AMAYA ARCHITECTS

ADDENDUM NUMBER 1

**DiLauro Residence
10 East Avenue
Milford, Connecticut**

Project Number 1275

1 Wall Detail Front of Building
 SK1 SCALE: 1/2" = 1'-0"

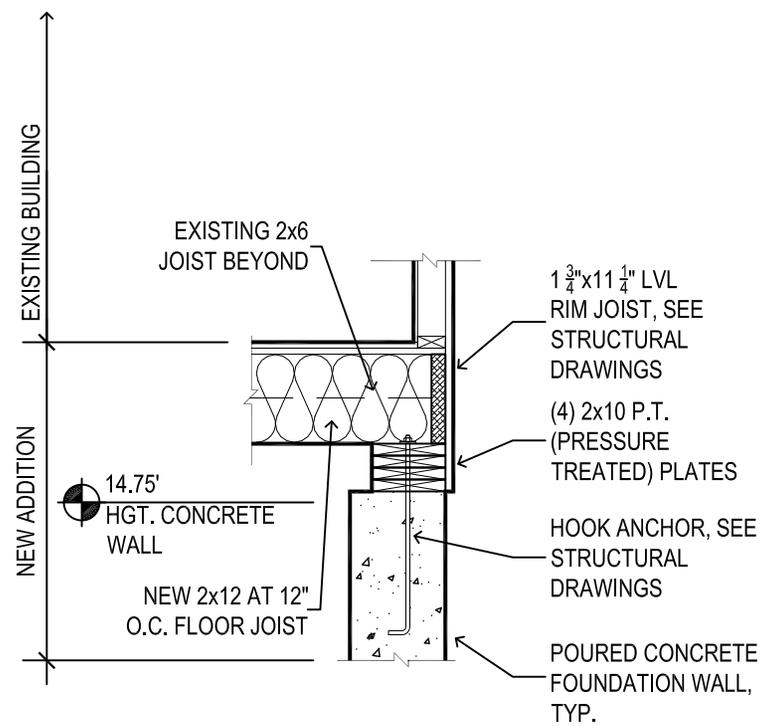
<u>Item #</u>	<u>Section/Dwg</u>	<u>Description</u>
1		Attached is a list of the Contractors present at the walk-thru on the 22 nd of December 2014 – for your reference.
2	SK1 Detail 1 and 2	Clarification – At the front section of the house (original porch), there should be two pressure treated wood plates bolted to the top of the foundation wall – At the rear section, there should be four pressure treated wood plates bolted to the top of the foundation wall – Note: The front section of the house (original porch) is sloped toward the east.
3		Clarification - The top of the Foundation Wall is at Elevation 14.75’.
4	Drawing E-1	Delete “Luminaire Schedule” on Drawing Sheet E-1.
5	Drawing E-1	Fixtures labeled as “E-Fixture” on the Electrical Plans (above front garage door and above rear man-door from garage /storage) shall be Item #680-9-15 as manufactured by Quorum International. Install fixtures horizontally in both locations.
